PRE-GATEWAY REVIEW – Information Assessment and Recommendation Report

Local Governmental Area:	Randwick	
Amended LEP:	Randwick Local Environmental Plan 2012	
Address:	137-151 Anzac Parade, Kensington	
Reason for review:	☒ Council notified proponent it will not support proposed amendment	☐ Council failed to indicate support for proposal within 90 days
Is a disclosure statement relating to reportable political donations under s147 of the Act required and provided?	☒ Provided	☐ N/A
	Comment: A disclosure of reportable political donations has been provided.	
Assessment Fee:	☒ Provided & correct	☐ Not provided / incorrect

Figure 3: Current and Proposed height of building controls. Source: JBA 2015

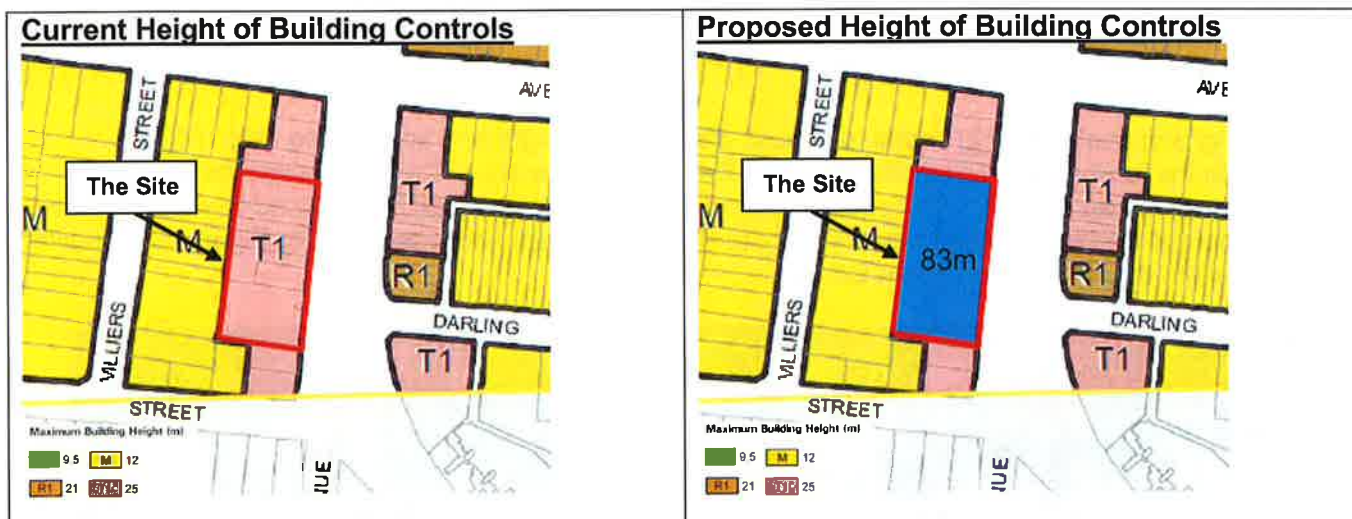
- retain the existing B2 Local Centre zone on the site (refer to Figure 2);
- increase the maximum building height for the site from 25m to 83m (refer to Figure 3); and
- introduce a maximum FSR for the site of 7:1 (refer to Figure 4).

- increase the maximum building height from 25m to 83m by amending the Height of Building Map; and
- introduce a maximum floor space ratio of 7:1 by amending the Floor Space Ratio Map.

Figure 4: Current and Proposed floor space ratio controls. Source: JBA 2015

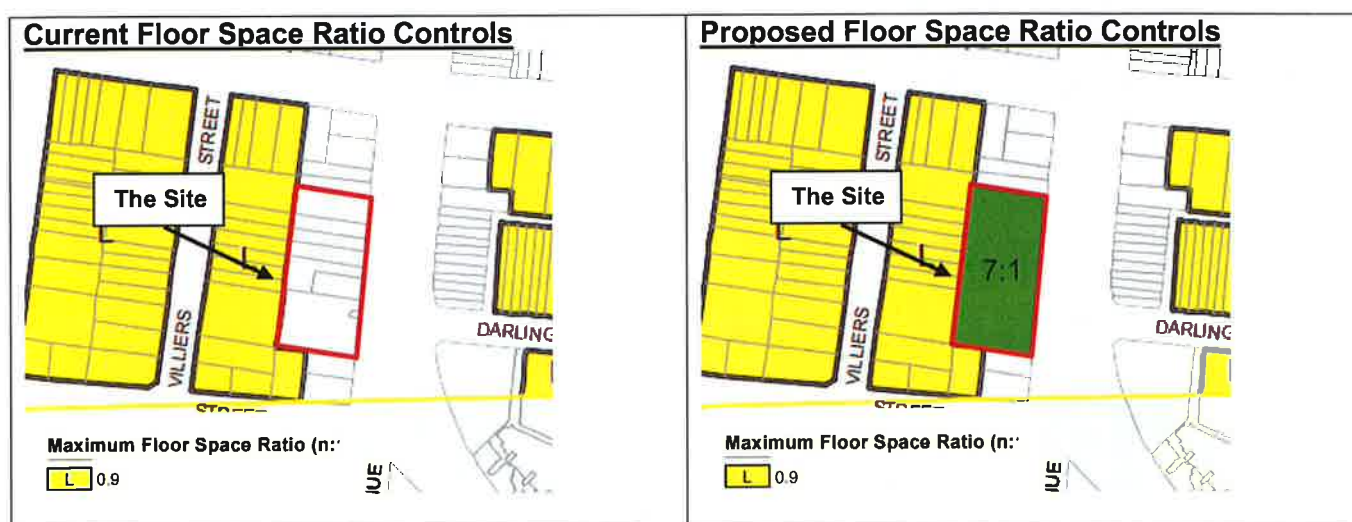
The planning proposal contains sufficient images and mapping of the site and of the surrounding context. It demonstrates the current land zoning and building height controls applicable to the site and the surrounding area. It also illustrates the proposed building height and FSR controls, but does not provide mapping for the current FSR controls.

Figure 6: DCP Proposed Layout of Block 8. Source: Randwick City Council 2013

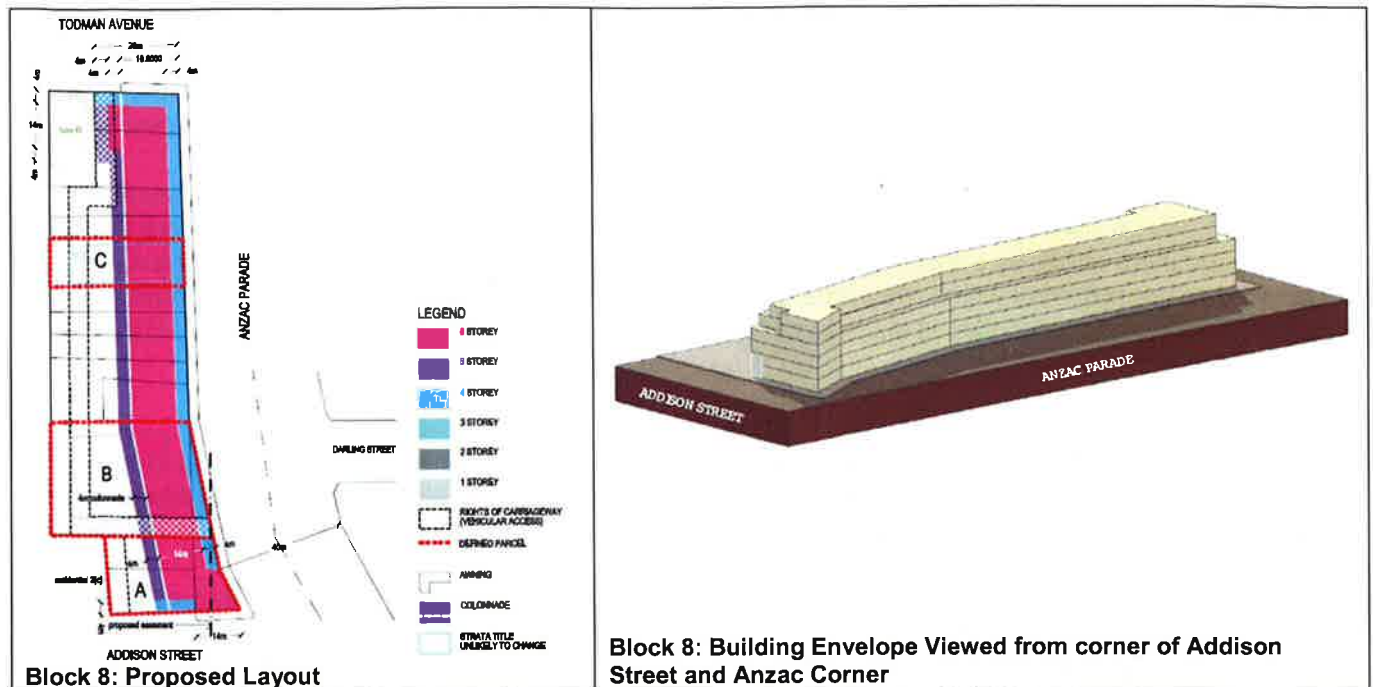
The site is subject to building envelope controls set out in the Randwick DCP 2013. The DCP sets out key building envelopes for Block 8 – Addison Street to Todman Avenue (see Figure 6). Council reports that these DCP controls established in 2001/02 have been consistently applied across the Town Centre, with a predominant maximum height of 25m for the town centre. The planning proposal will significantly exceed these controls.

- street wall height of 4 storeys to Anzac Parade and Todman Avenue, 6 storeys to the central part of the building and stepping down to 5 storeys to the rear adjoining the R3 Medium Density Residential zoned land.

Figure 7: Proposed Built Form viewed from Anzac Parade. Source: Kannfinch 2015

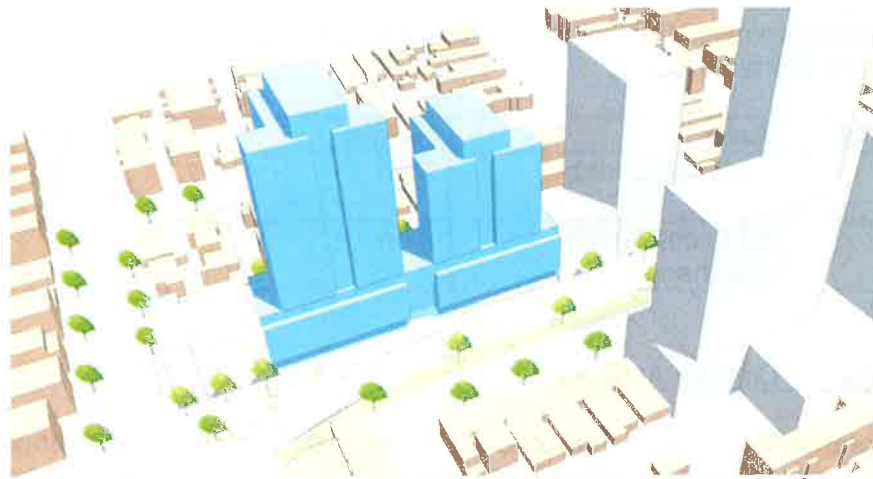
The scale of the proposed development will be out of character with the existing development along Anzac Parade and the surrounding medium density residential development to the west and south of the site. The scale, bulk and height of the proposed development is of concern and does not reflect the height of buildings currently in this locality. Development surrounding the town centre is zoned R3 Medium Density Residential under the LEP, which has a maximum building height control of 12m.

There is no transitioning in heights between the proposal and adjoining properties, particularly the adjoining properties within the block to west behind Anzac Parade. The shadow diagrams indicate extensive shadowing which will impact upon the amenity of adjoining lower scale residential development to the west and south as well as impacting on development along the western side of Anzac Parade.

As discussed in section 4.2.2, the SJB analysis of the corridor presents the subject proposal in montages and in the context of the proposed increasing densities of the Corridor and the desired future character, rather than in its existing context.
